99-101 DANFORTH STREET

Your permit to make alterations to 101 Danforth Street can not be issued at this time because this department does not know the dimensions of the proposed bedrooms or what type of ventilation is being supplied to these rooms.

To make alterations to dwelling, to erect partitions to make additional bedrooms in apts, as per plans. 4 sheets of plans, no structural changes.

Fourth Floor  
Danforth St.

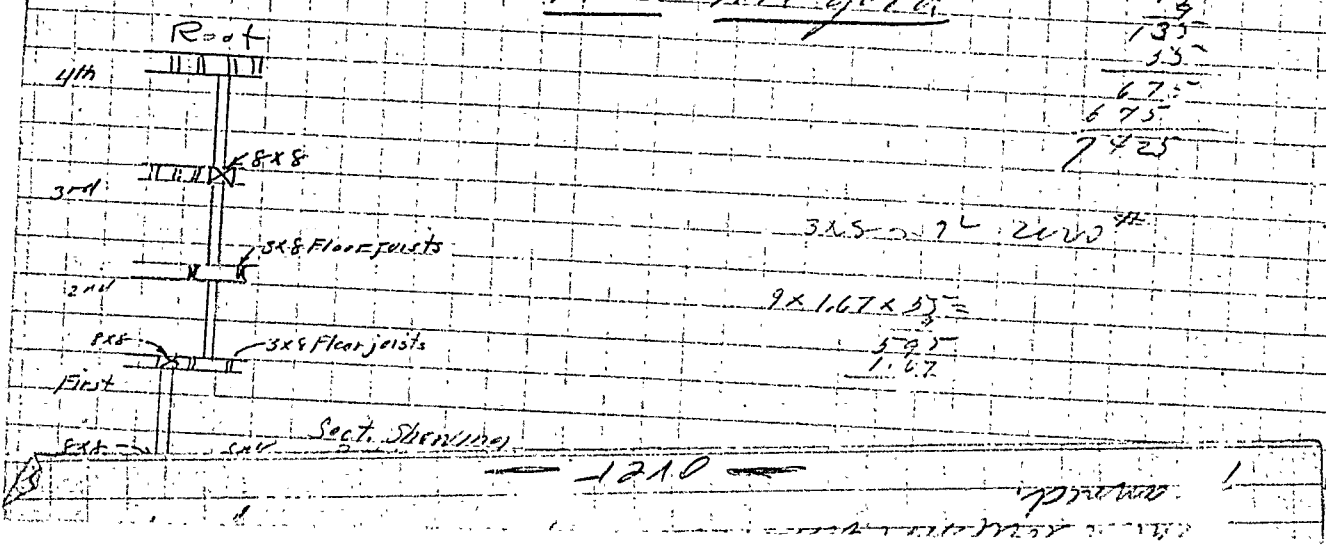
Check present 6x8 center guide <sup>right angle to Danforth St.</sup> under 4th floor and probably at all levels.

6x8 on 15' span grid for 48x7 (assumed 15' span)  
Area  $9 \times 15 \times 55 = 7425$  Net grid
